SUBJECT: GRAND GULF NUCLEAR STATION – NRC SPECIAL INSPECTION REPORT
05000416/2016008

GRAND GULF NUCLEAR STATION – NRC SPECIAL INSPECTION REPORT
05000416/2016008 – DATED OCTOBER 27, 2017

Report: 05000416/2016008

Figure 3 – Top of LOSDC Event Tree

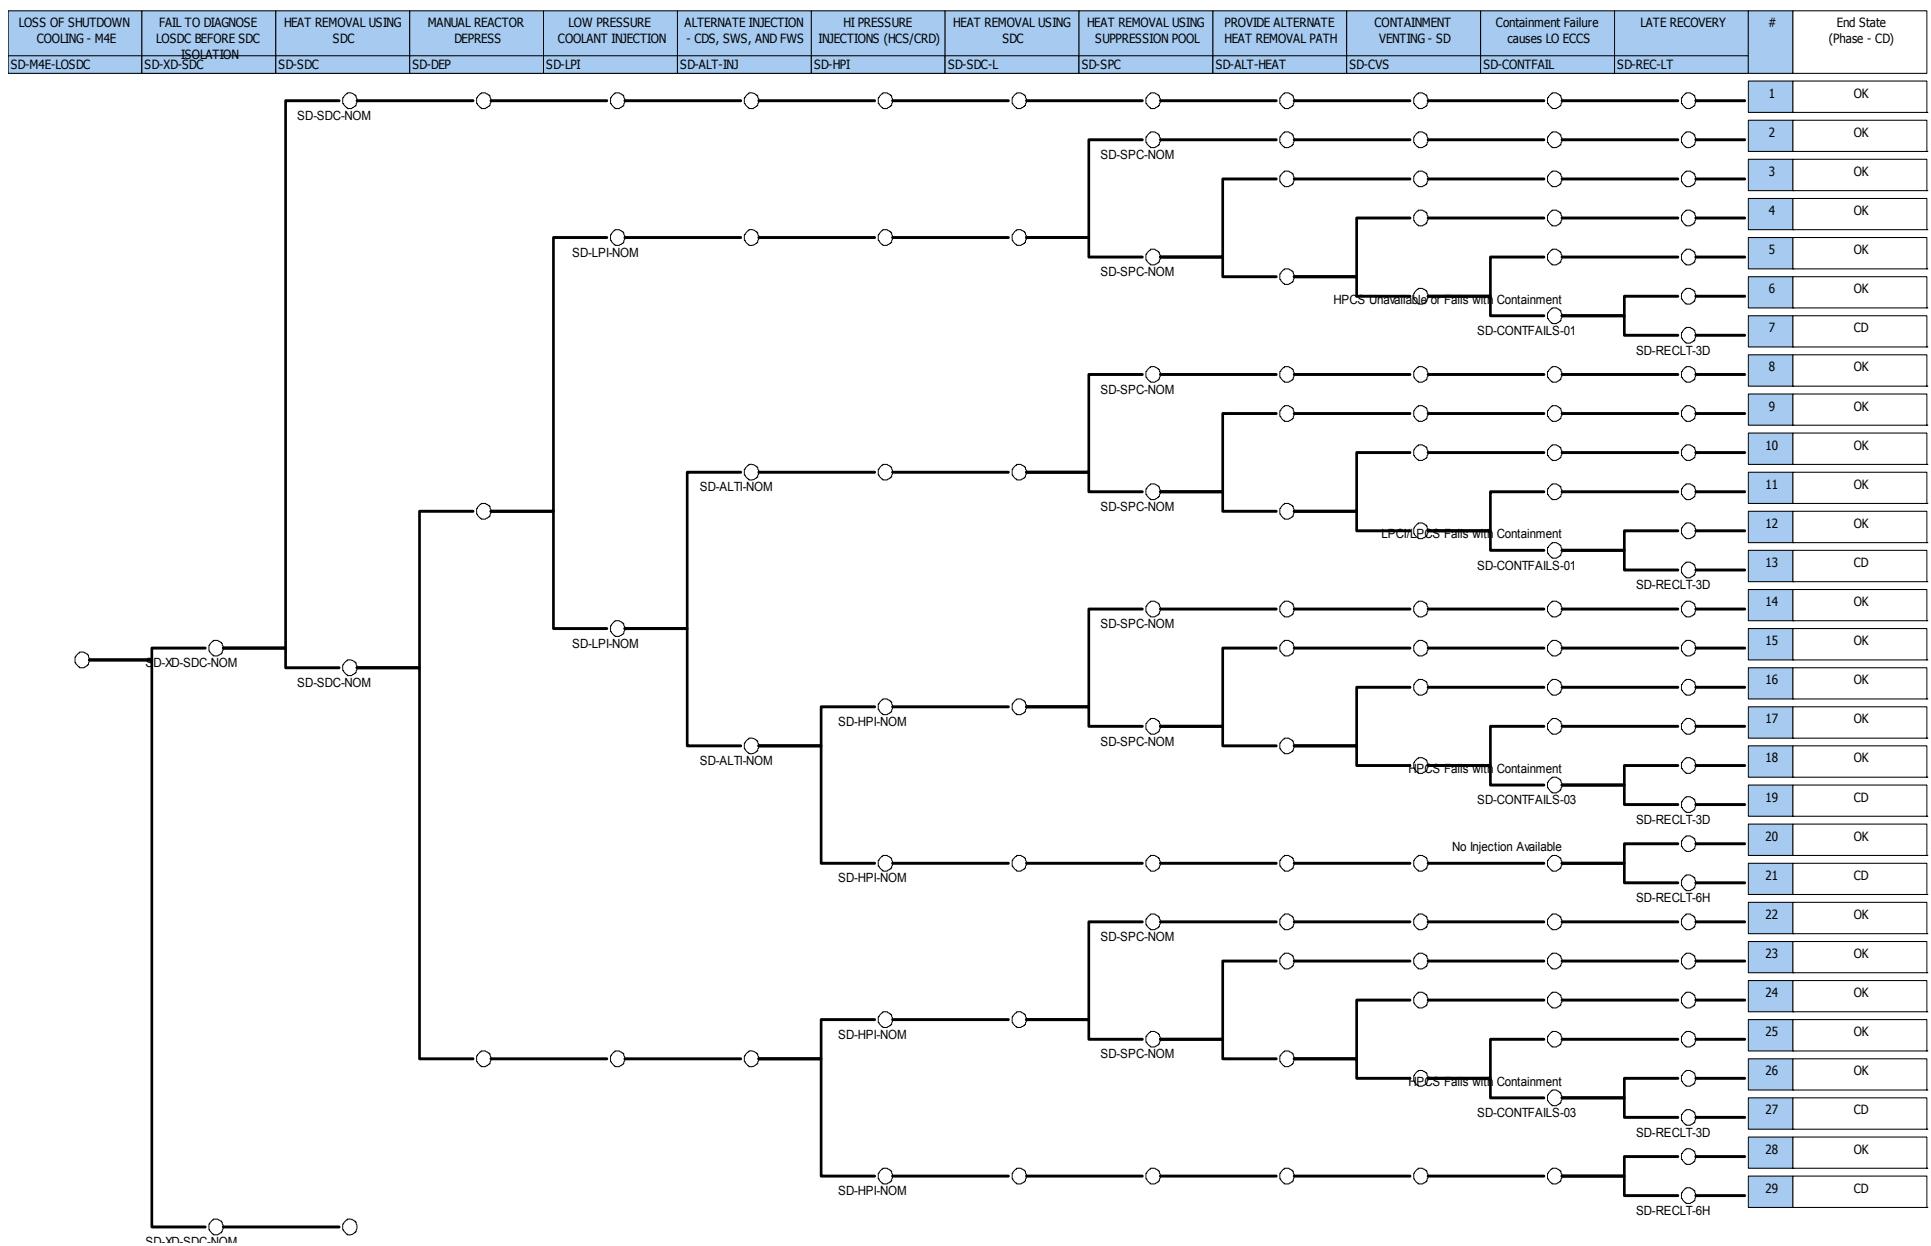
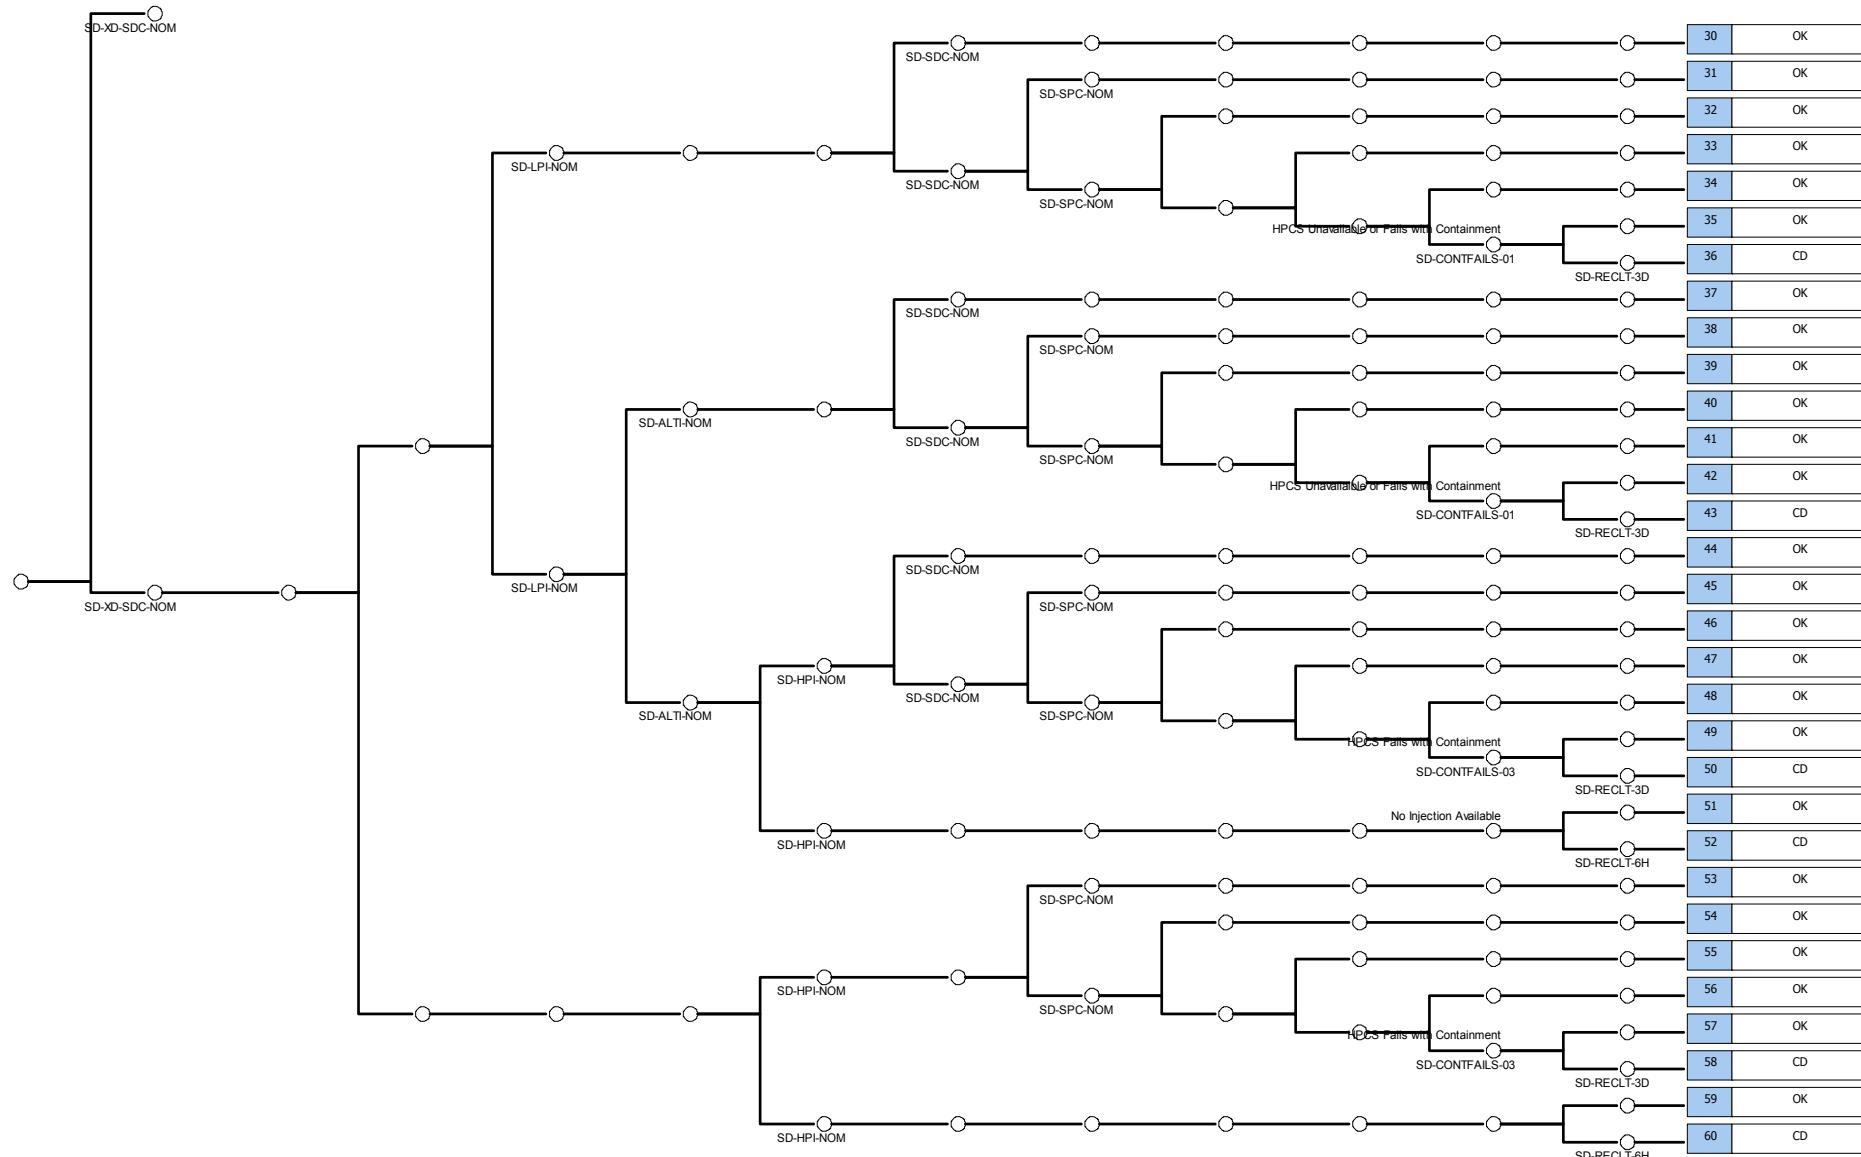
Dominant Sequence: The dominant sequence for Case 1 is Sequence 7 in the LOSDC event tree (as shown in Figure 3), which includes the following top events:
